### Proposed Revisions to a Standard Plans Index

Index Number: 700-091

Index Title: Catwalk Details

INDEX  
700-091

**CATWALK ASSEMBLY**  
(Cantilever Shown, Span Similar)

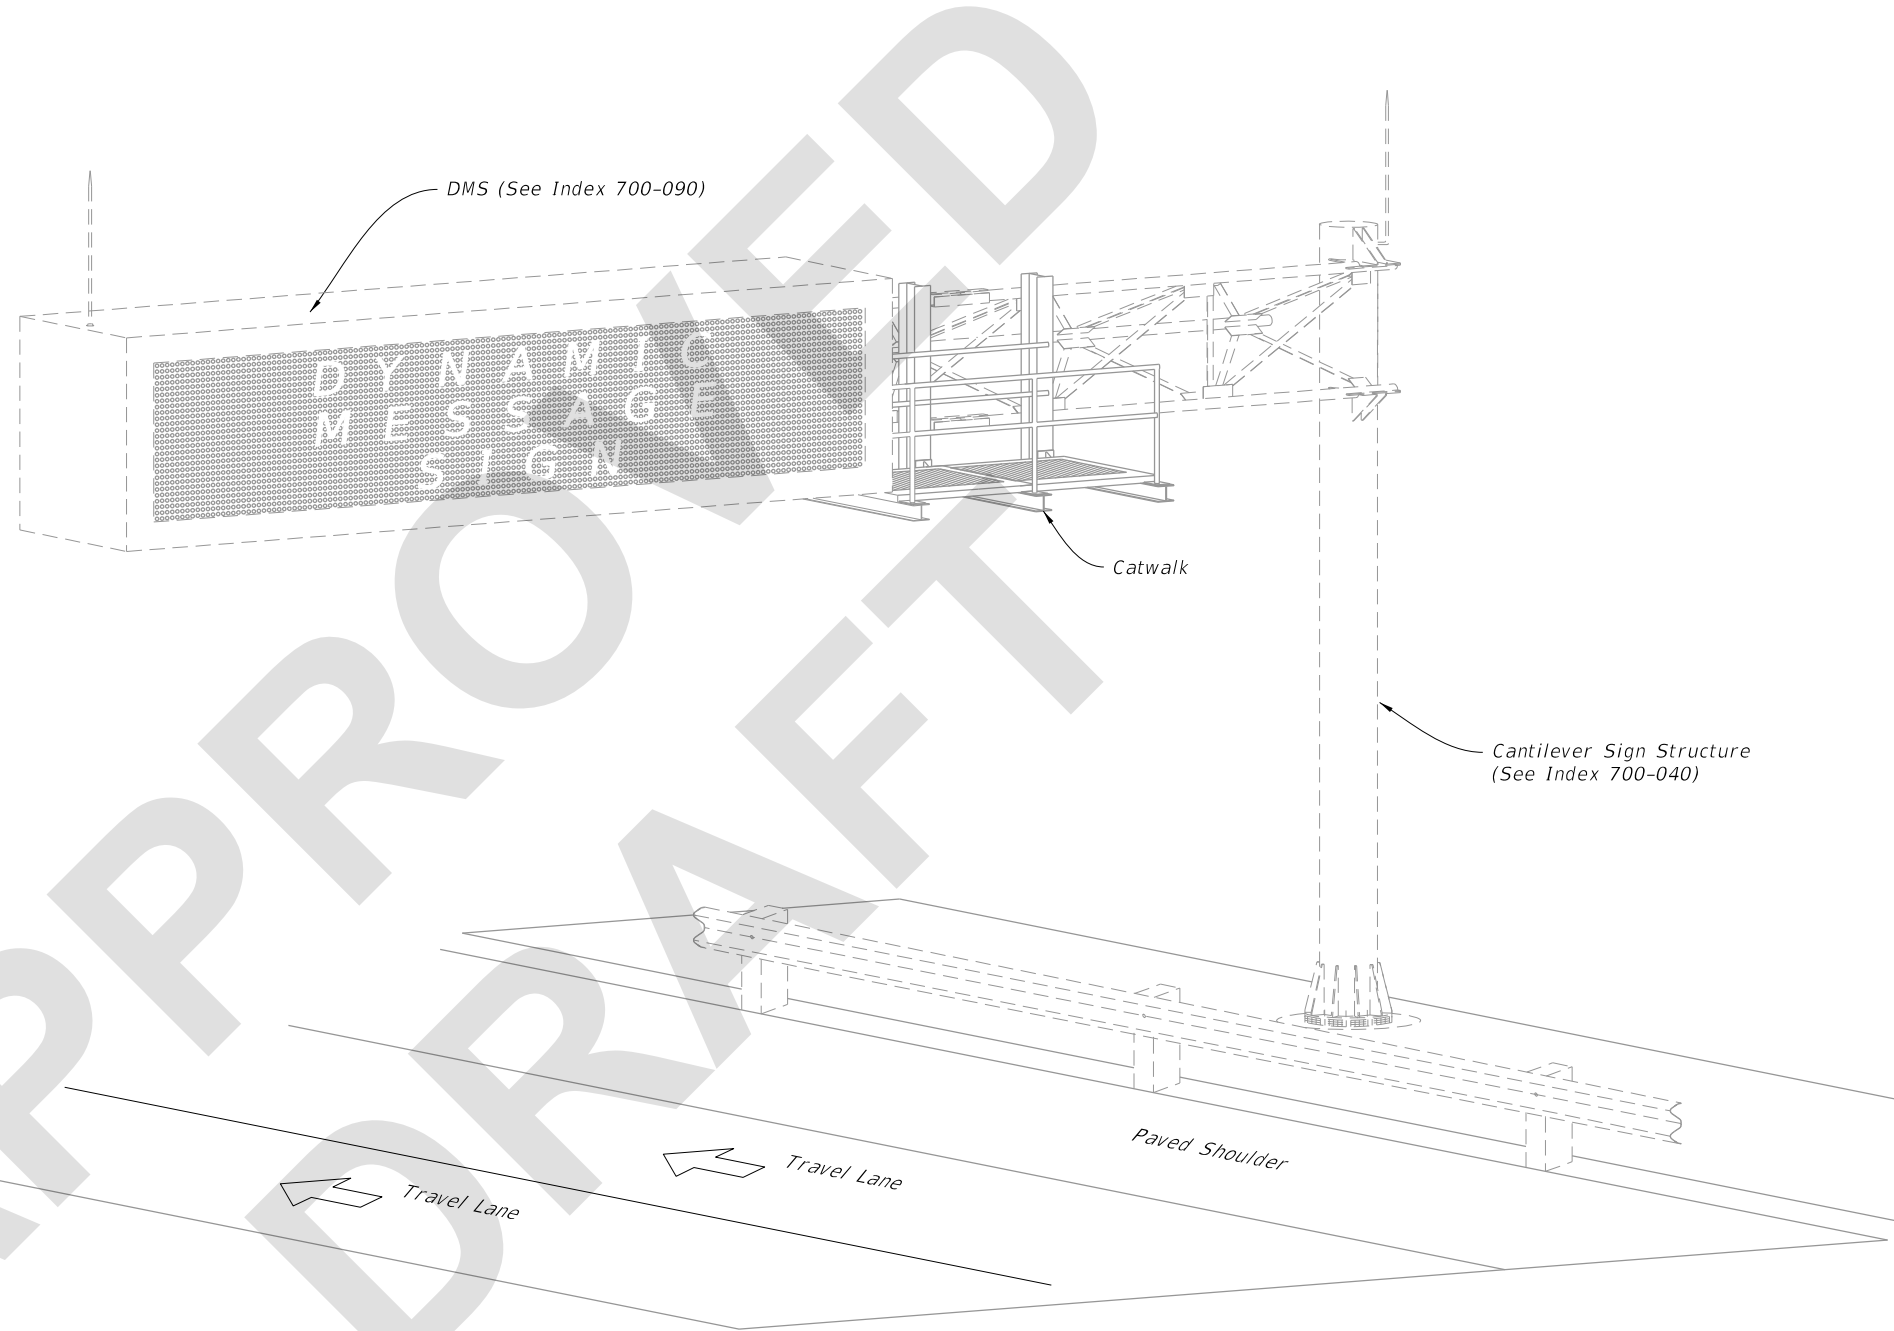
**UPDATED NOTE: Meet the requirements of Specification 700.**

- ~~1. Work this Index with Specification 700.~~
2. Shop Drawings are required:
  - A. Provide length as shown in the Plans
  - B. Design in accordance with AISC, AASHTO, and OSHA requirements

~~9. Welding:~~

~~10. Materials:~~

- ~~A. Steel Plates ASTM A 36 or A709 Grade 36.~~
- ~~B. W- Sections: ASTM A572 Grade 36 or 50.~~
- ~~C. Steel Pipe Railings or Structural Tubing: Specification 962~~
- ~~D. High Strength Bolts, Nuts and Washers: Specification 962~~
- ~~E. U-Bolts, nuts and washers: Specification 962~~

~~11. Coatings/Galvanizing:~~

~~Hot dip galvanize support frame after fabrication and galvanize non-stainless steel fasteners in accordance with Specification 962.~~

**DELETED**

**GENERAL COMMENT: Some material information was deleted. Information is either already covered in Standard Specifications OR will be added to Section 700, 962 or 965 in conjunction with these revisions.**

1. Meet the requirements of Specification 700.
2. Shop Drawings are required:
  - A. Provide length as shown in the Plans
  - B. Design in accordance with AISC, AASHTO, and OSHA requirements

- B. AASHTO M181 Type II - Aluminum Coated Steel, No. 9 gage (coated wire diameter), coated at the rate of 0.40 oz./ft<sup>2</sup>.
8. Install 2" NPS (Sch. 40) guiderail and posts: ASTM A53 Grade B for standard weight pipe.
